**Addendum No. 2**

**Playfield Lighting Improvements for Madera High School  
& Madera South High School**

**BID No.101014**

Re: **MHS and MSHS Sports Lighting Projects**  
**Addendum #1 Electrical Items**

# SPORTS LIGHTING CONTROLLER MOUNTING DETAIL

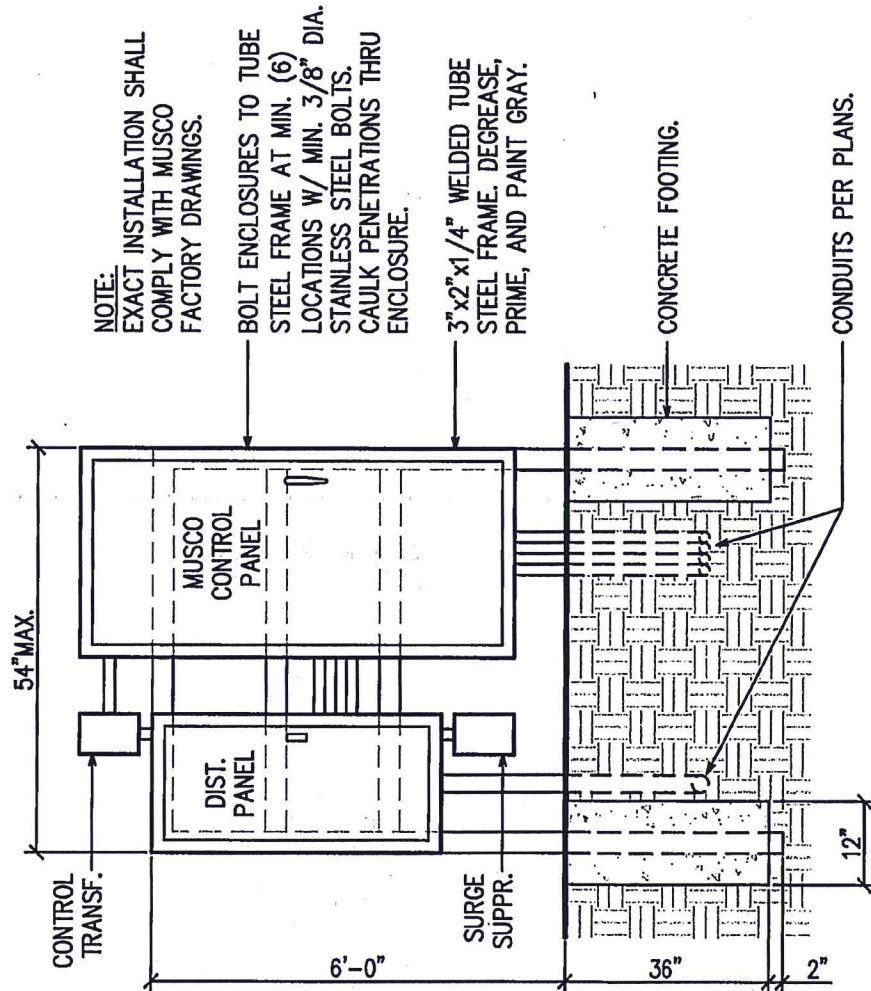
1. Refer to sheet E1.
  - Replace detail 2/E1 "Electrical Cabinet Pad Mounting Detail" with attached detail 2/E1 "Sports Lighting Controller Mounting Detail".
2. Refer to sheet E4.
  - Replace detail 1/E4 "Single Line Diagram" with attached detail 1/E4 "Single Line Diagram".
3. Refer to sheet E5.
  - Replace detail 1/E5 "Single Line Diagram" with attached detail 1/E5 "Single Line Diagram".

The Musco lighting controller requires a separate power panel to feeds for control power, lighting circuits, surge suppressor, and surge suppressor monitoring. The attached revised details reflect this requirement. All work shall conform with the factory Musco drawings and instructions.

# SPORTS LIGHTING CONTROLLER MOUNTING DETAIL

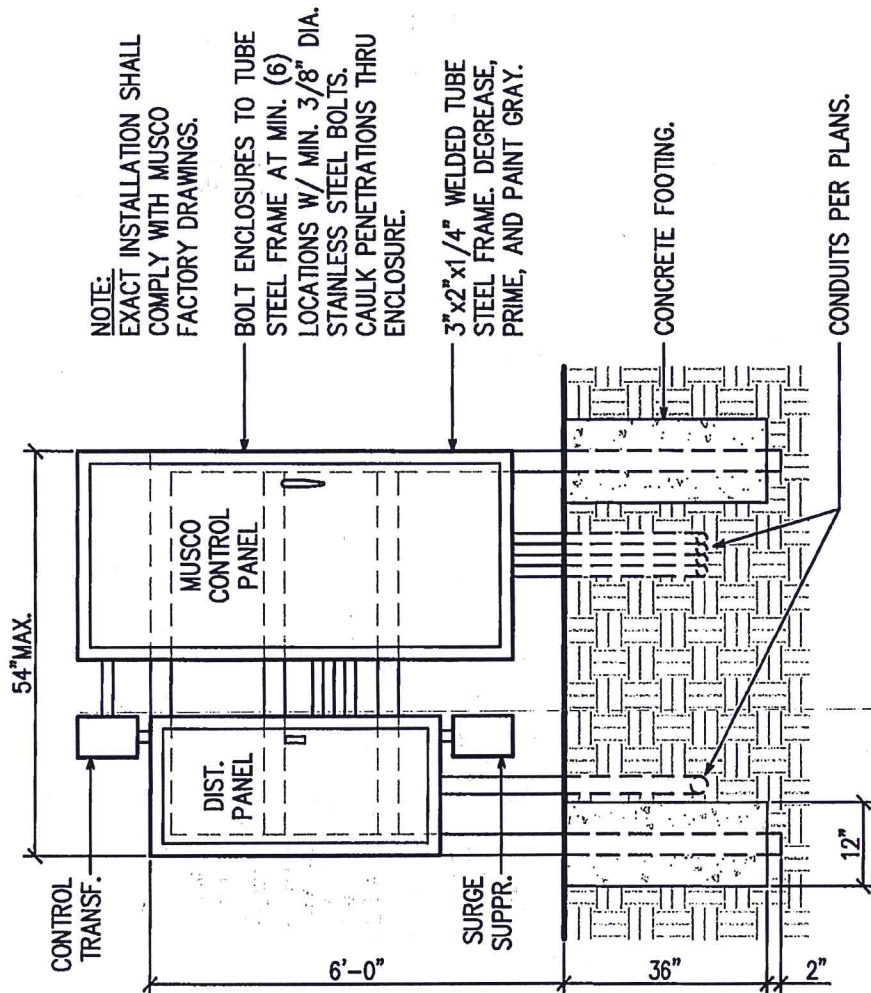
1. Refer to sheet E1.
  - Replace detail 2/E1 "Electrical Cabinet Pad Mounting Detail" with attached detail 2/E1 "Sports Lighting Controller Mounting Detail".

SINGLE LINE DIAGRAM

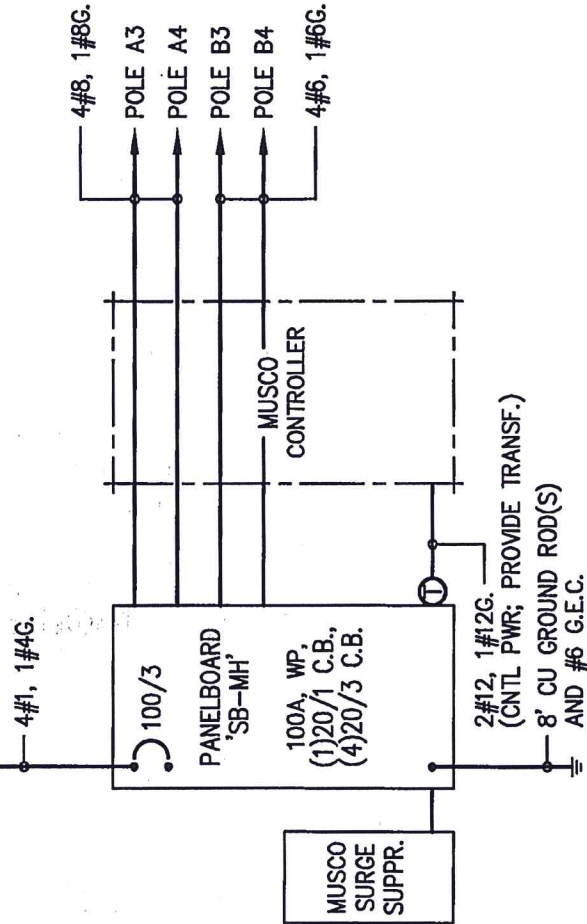
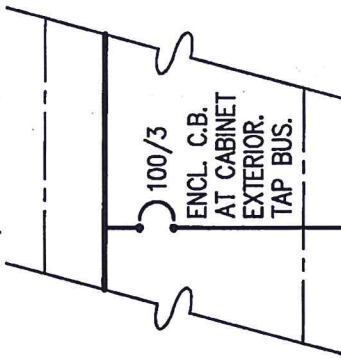
2. Refer to sheet E5.
  - Replace detail 1/E5 "Single Line Diagram" with attached detail 1/E5 "Single Line Diagram".
3. Refer to sheet E6.
  - Replace detail 1/E6 "Single Line Diagram" with attached detail 1/E6 "Single Line Diagram".
4. Refer to sheet E8.
  - Replace detail 1/E8 "Single Line Diagram" with attached detail 1/E8 "Single Line Diagram".

## DRAWING KEY NOTES ①

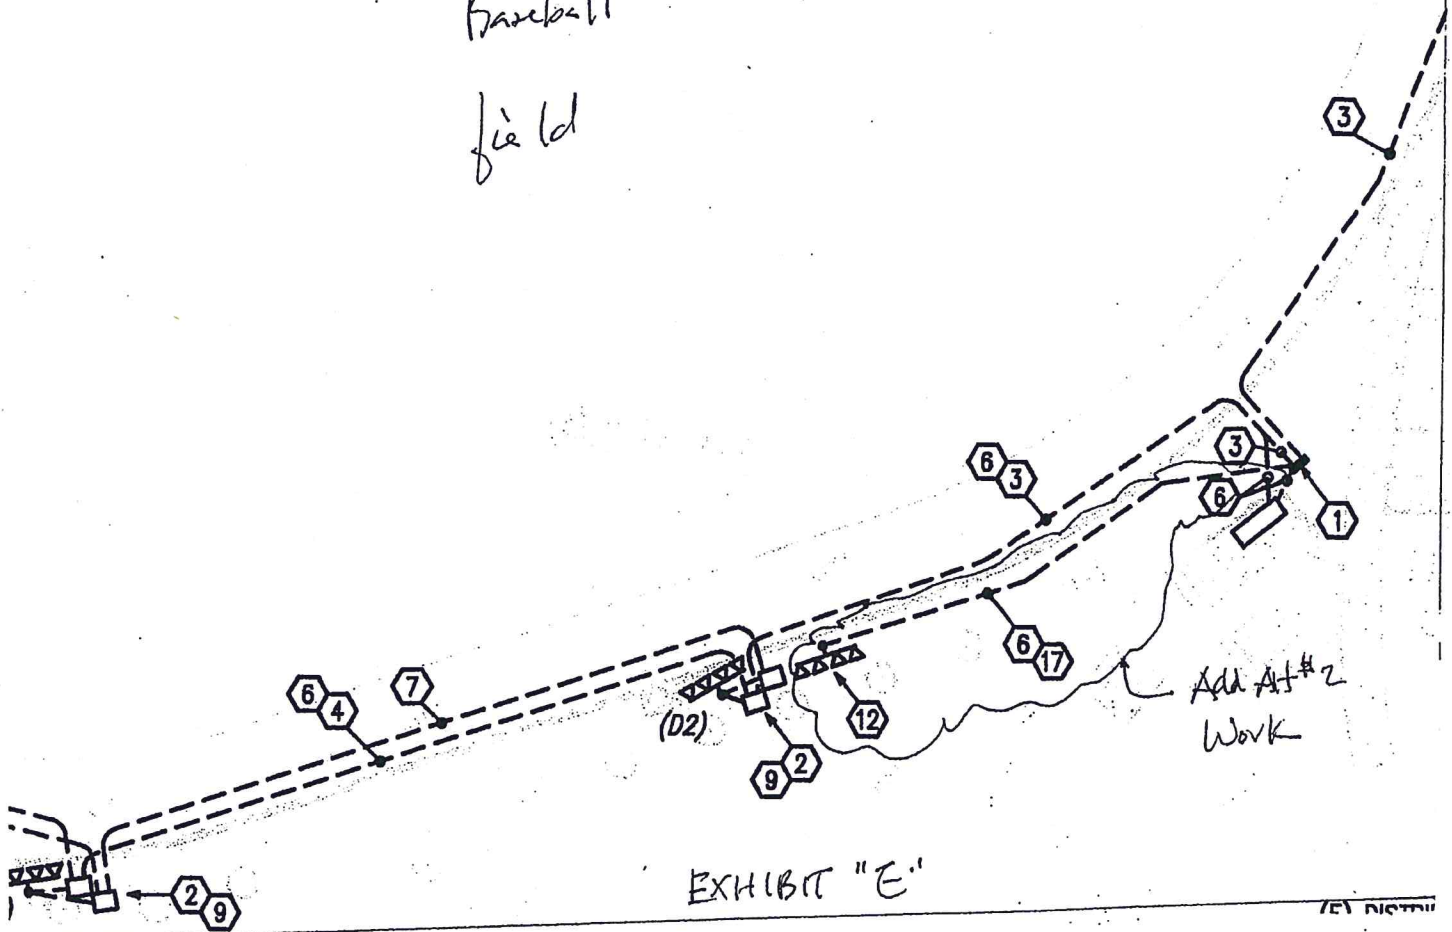
12. BASE BID: REMOVE (E) LIGHT POLE. <sup>Reinstall</sup>  
ALTERNATE #2: <sup>With new footing</sup> ROTATE EXISTING LIGHT POLE TO POINT AT DISCUS/JAVELIN FIELD. PROVIDE TRANSFORMER ADJACENT POLE; BRING POWER CONDUIT INTO POLE. RE-AIM FIXTURES PER MUSCO.

13. REMOVE EXISTING CONCRETE AND REPLACE. SEE CIVIL DWGS.
14. BASE BID: REMOVE (E) LIGHT POLE AT LOCATION OF NEW LIGHT POLE.  
ALTERNATE #3: REMOVE EXISTING LIGHT POLE AT LOCATION OF NEW LIGHT POLE AND INSTALL AT SOCCER FIELD. SEE SHEET E10.
